Product Change Notification – **PCN F01/2023**

SUBJECT: CP-P7/4-1S-A (433500025991)

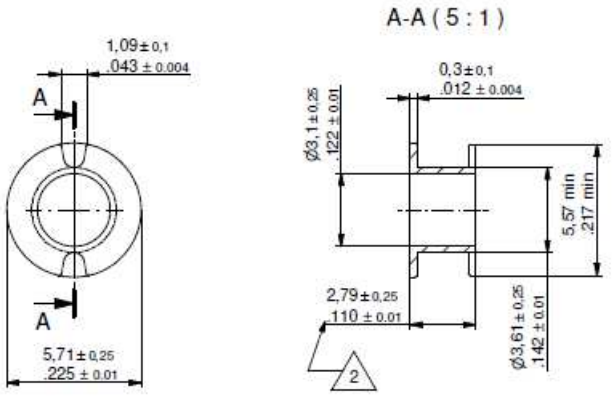
Change Description: Changed dim 2.69 to 2.79mm and tolerance from ±0.05 to 0.25mm

2 Changed dimension from 2.69 to 2.79 and changed tolerances from ±0.05 to ±0.25
